Author's responses

Dirk Mittelstrass, Freiberg and Sebastian Kreutzer, Aberystwyth, March 29, 2021

Response to reviewer #1

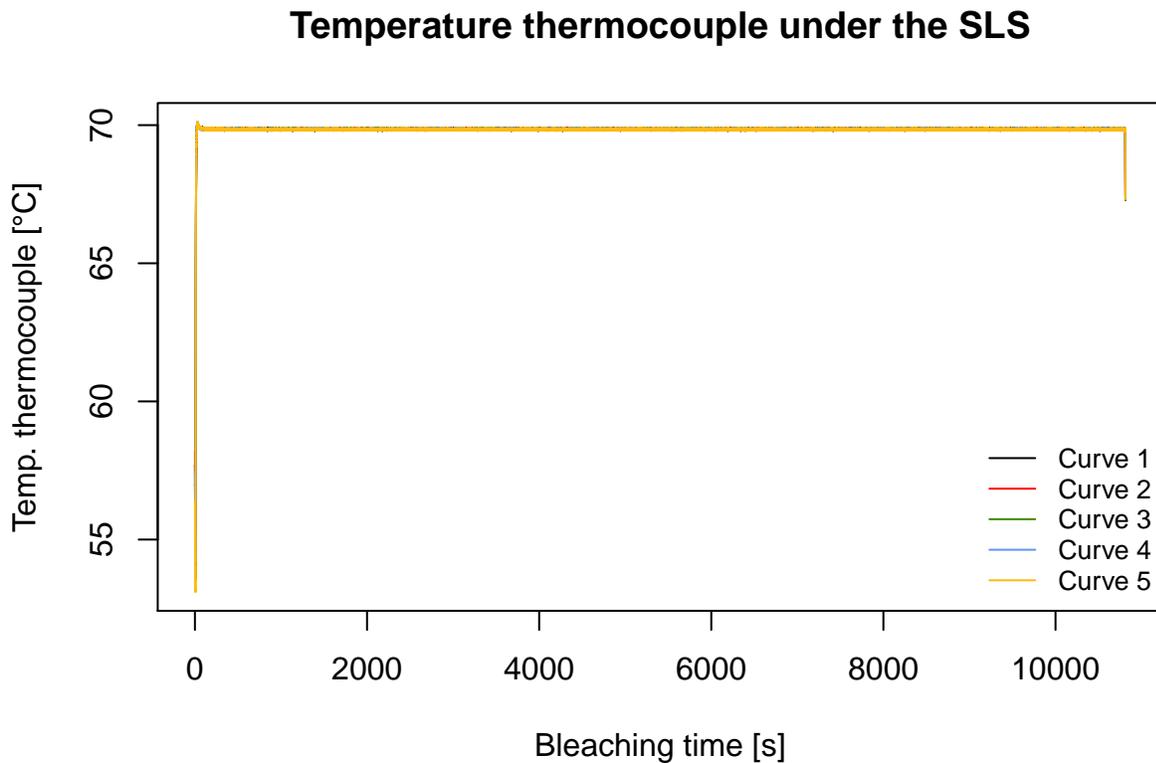
Moreover, the UV intensity has been doubled. An increase in UV induces a higher temperature during bleaching, which can activate a shallow TL peak (at ~120C at 10C/s, Huot et al., 2015). I am therefore not convinced that:

1. 1hour pause is sufficient for the thermocouple to completely cool down (see Huot et al., 2015 fig. 3) and for the phosphorescence signal to completely disappear,
2. and that the RFreg signal truly compares with the RFnat signal (if the shallow TL peak has been indeed activated during bleaching).

This is a justified claim, and it can be tested quickly. The thermocouple in the reader, installed in the sample arm, records the bleaching temperature (here at 70 °C). If your claim is correct, we should see a significant increase in the thermocouple's temperature over the 10,000 s of bleaching. Below I, exemplarily, extracted all temperatures recorded during the sample's bleaching with the manuscript's settings for the sample TH0. The R script may ease an additional inspection and show how I extracted the data. The here used dataset is part of the dataset available on Zenodo (Kreutzer & Mittelstrass, 2021).

The figure shows that the thermocouple's temperature remains very stable over 10,800 s (the bleaching time), even with the higher UV power settings. The true sample (grain) temperature is likely slightly higher. However, suppose the higher power settings would have caused a temperature rise, such an increase should be visible in the plot; in particular over such a long time. Luckily, a temperature increase is not visible. Moreover, the temperature stayed at the target temperature of 70°C. Hence, I am convinced that our settings are justified and did not bias our results.
